ADDENDUM NO. 2

**New Premium 63 Site Loop Campground
St. Francois State Park
Bonne Terre, Missouri
PROJECT NO.: X2317-01**

August 29, 2025

1/4" = 1'-0"

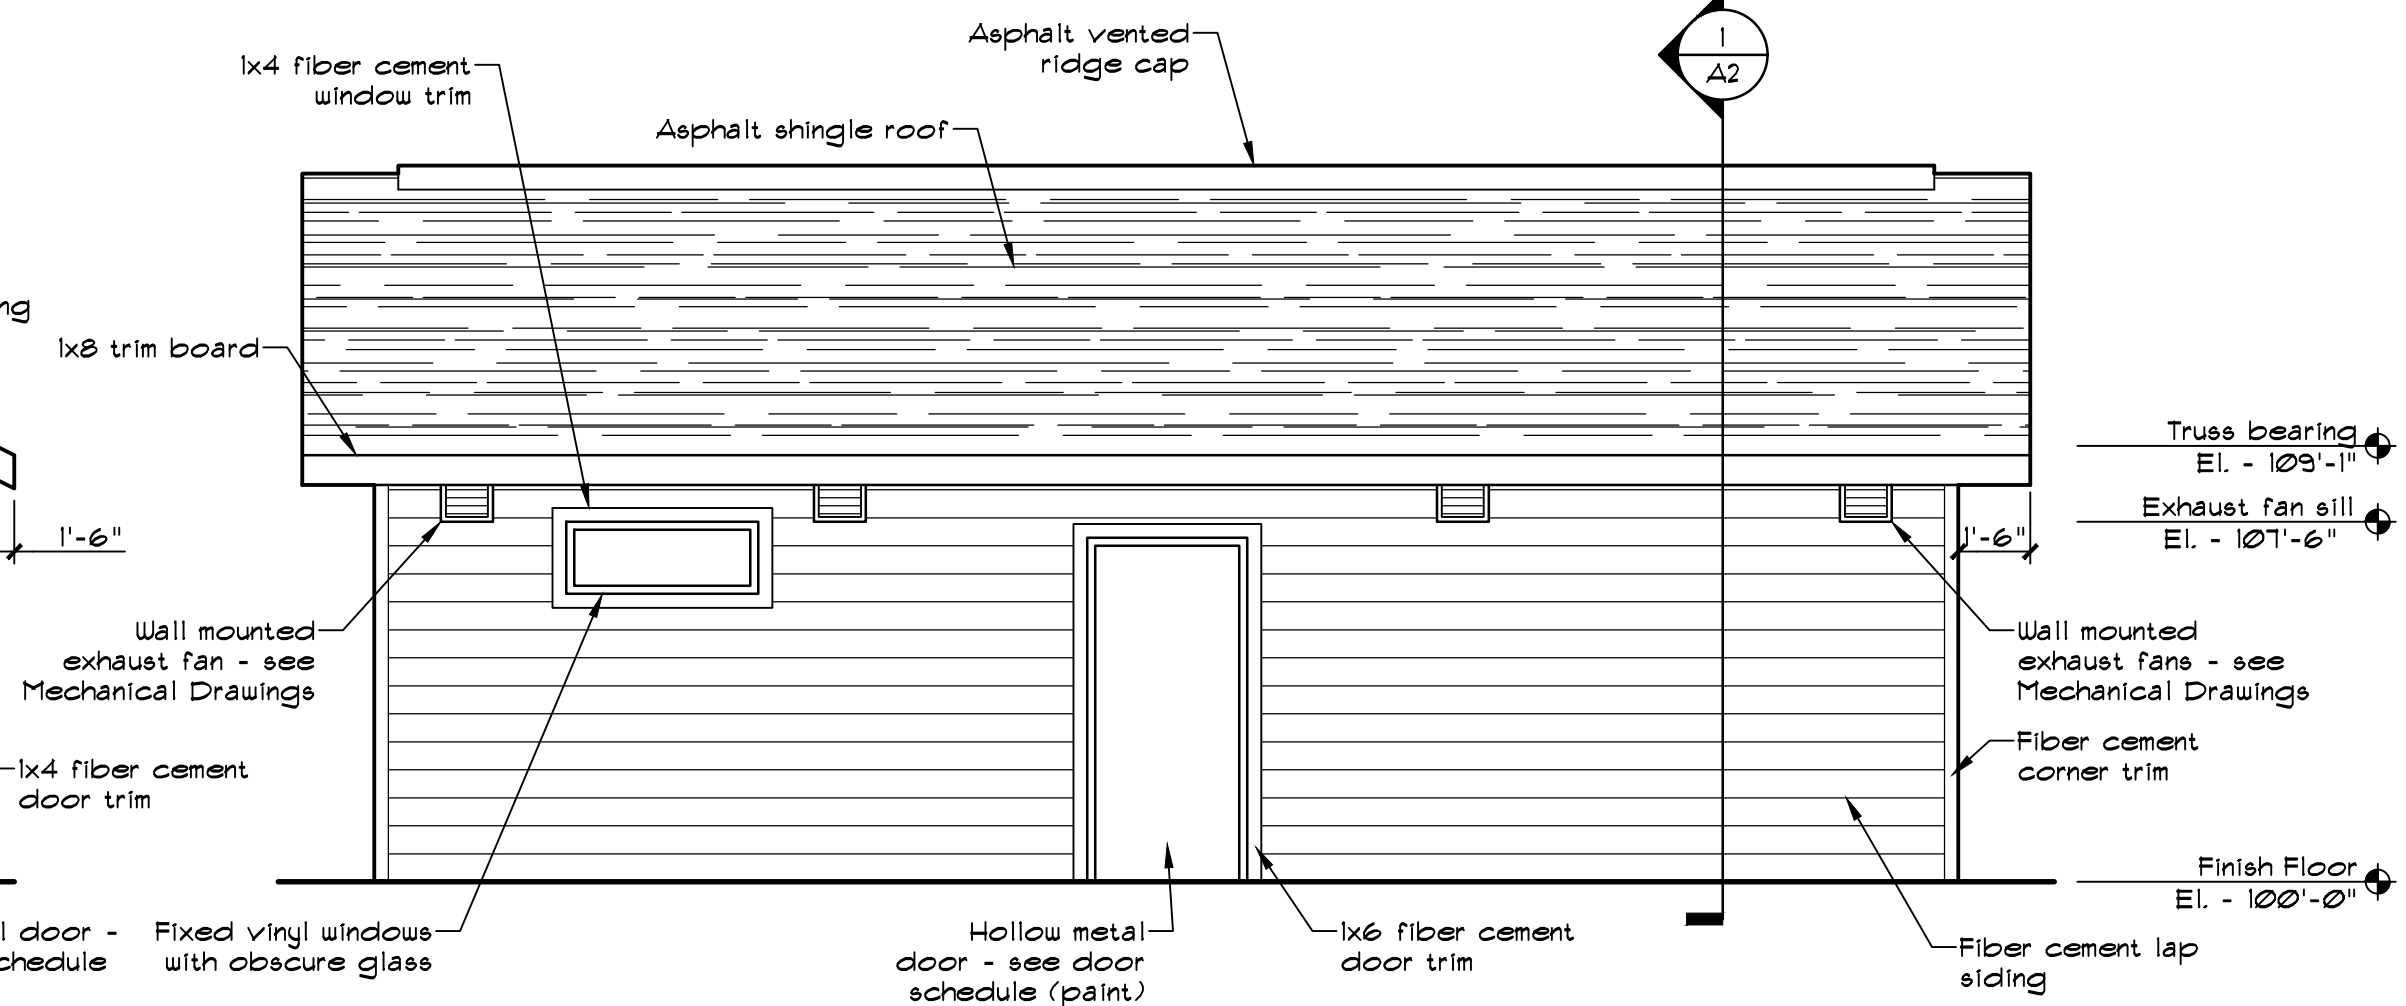
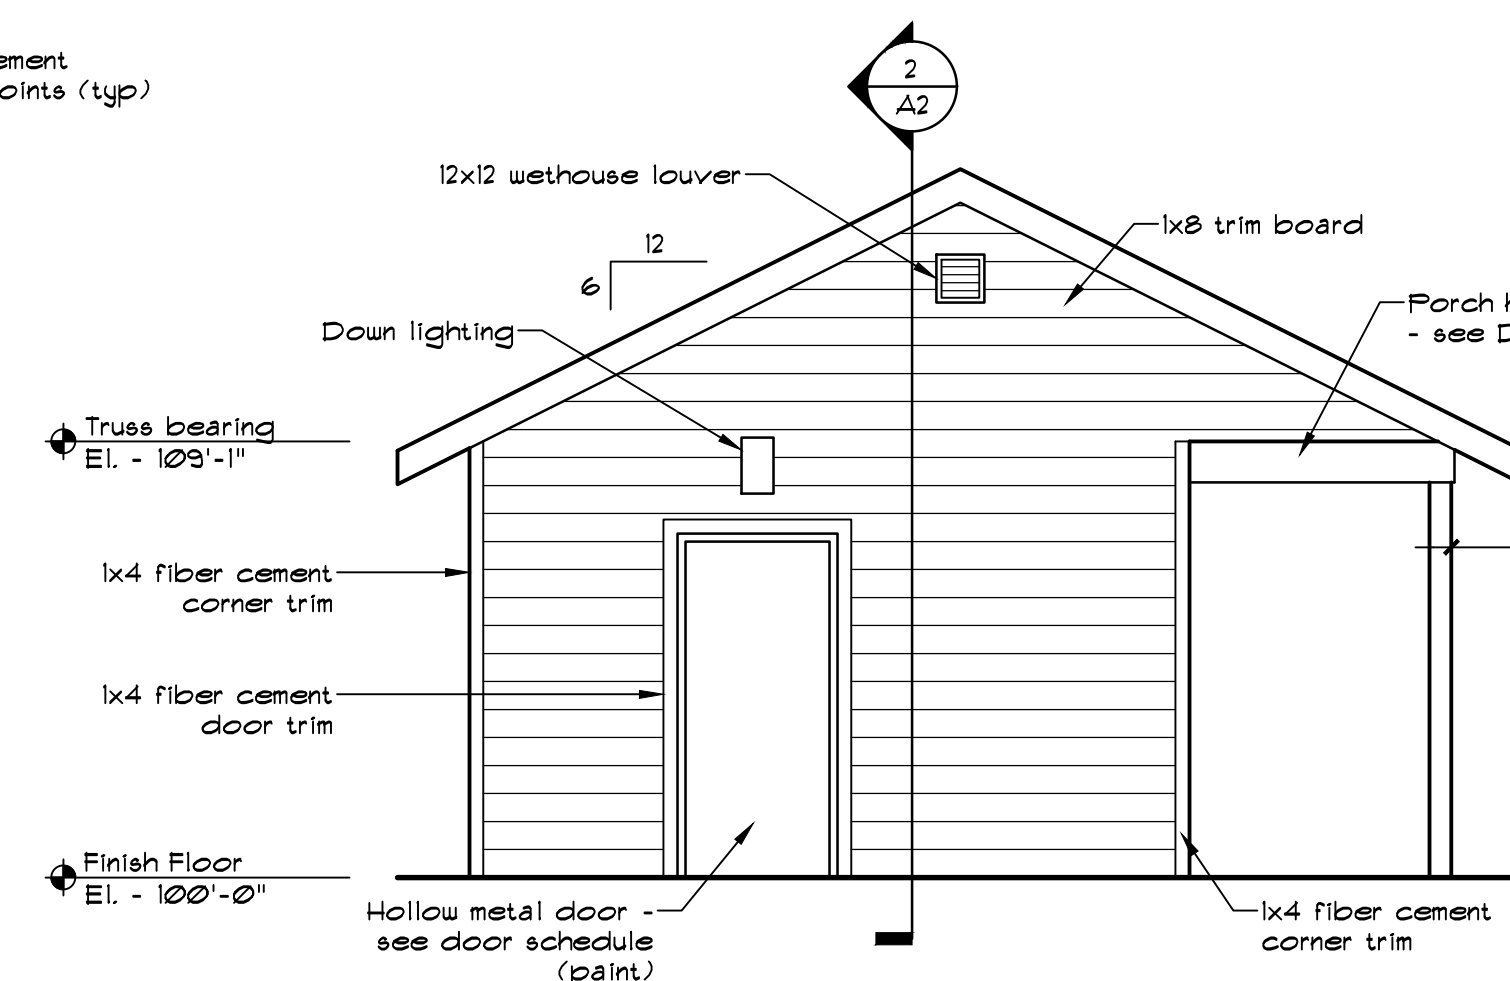
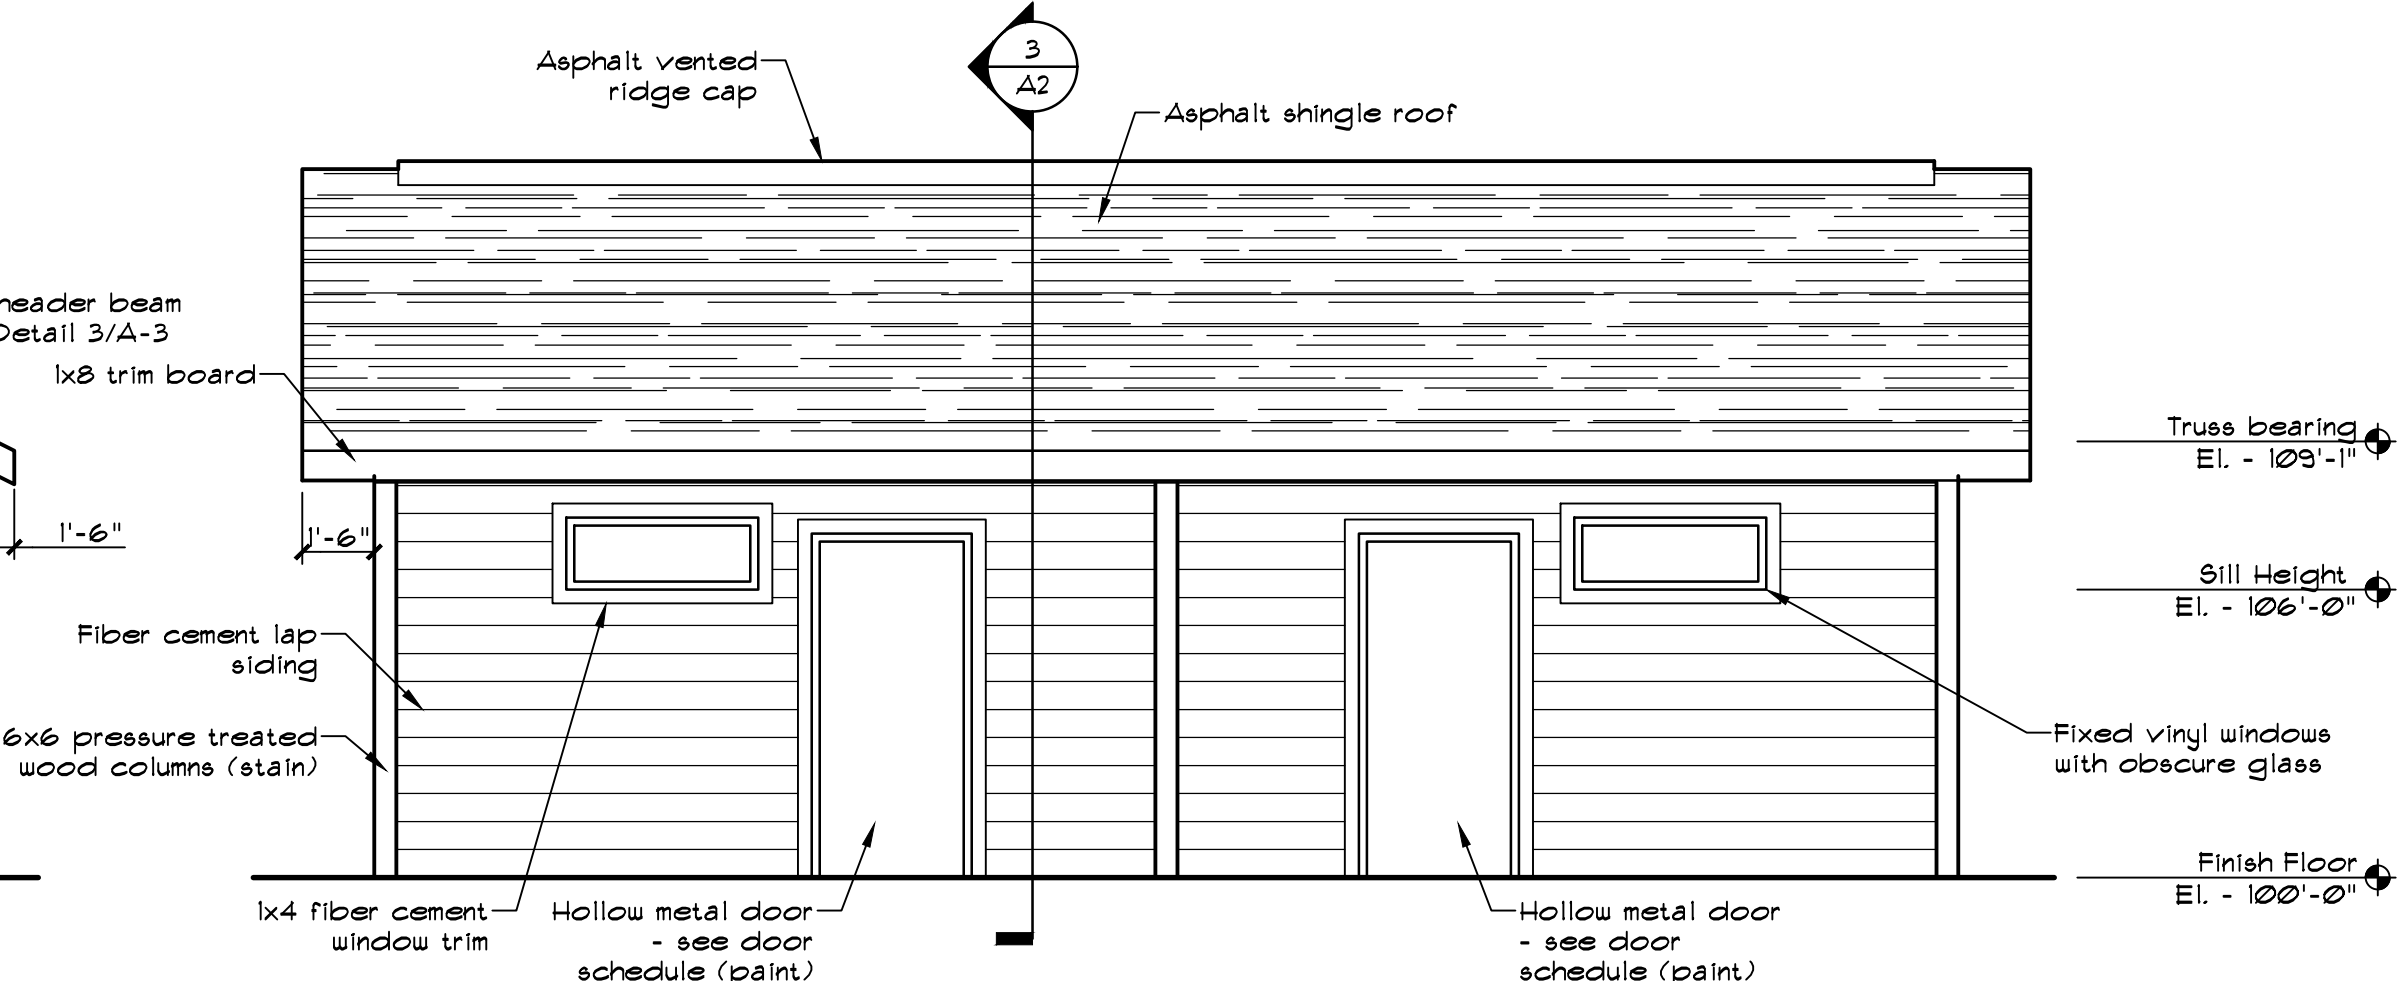
1. Modification: Changed wall thickness for plumbing walls.
2. Modification: Updated dimensions to match wall changes.
3. Modification: Updated partition type tags.
